Flight Procedures Cover Page	Task Action: FLIGHT CHECK	Task Type : IAP	Estimated Chart Date: 07/11/2024	APWS Task ID: 3A91AADBFE2B4D8BB26FEF3B02EE21F5	APWS Project ID: 76D9EE00AC824947831E8152E6B173AB
Procedure: RNAV (GPS) Z RWY 15 AMDT 1		Enroute: NO	Specialist: Donkor, Kweku		Agreement Number:
Airport ID: KASE			Airport City: ASPEN		State: CO
Facility ID:	Facility Type:	Flight Inspection Reman	к Туре:

RNAV (GPS) Z RWY 15

1. Flight Procedure Identification: ASPEN, COLORADO, ASPEN-PITKIN COUNTY/SARDY FIELD, RNAV (GPS) Z RWY 15 SPECIAL

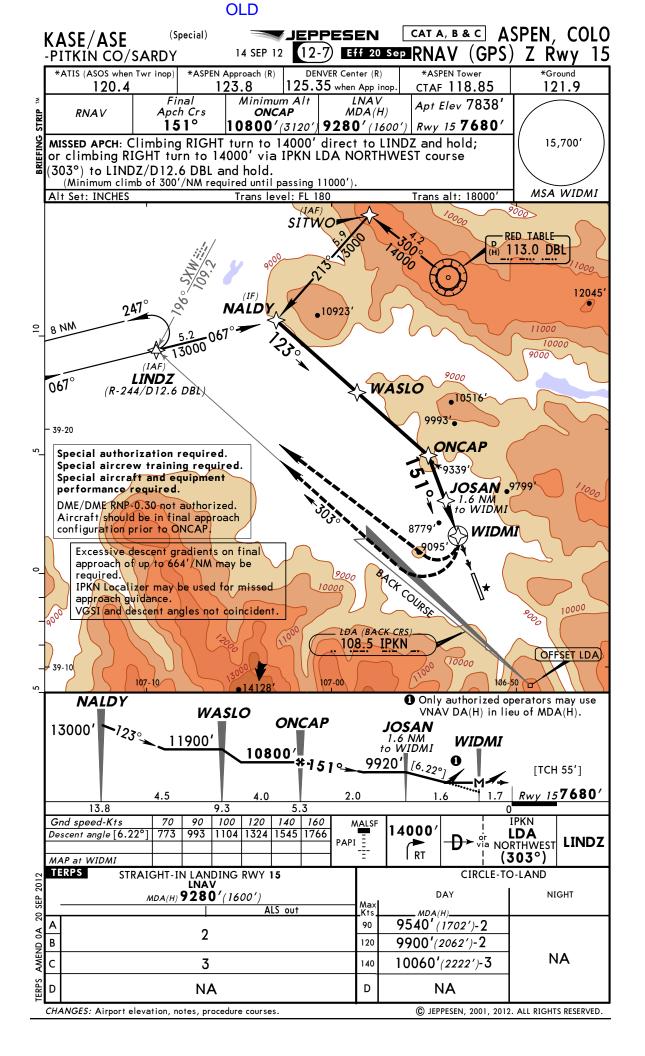
Procedure Comments: CIRCLING ICON T-NOTAM PROJECT RESULTING IN FULL AMENDMENT.

FAF ALTITUDE CHANGED FROM 10800 TO 11400.

WAIVER (GPA/VDA/CG).
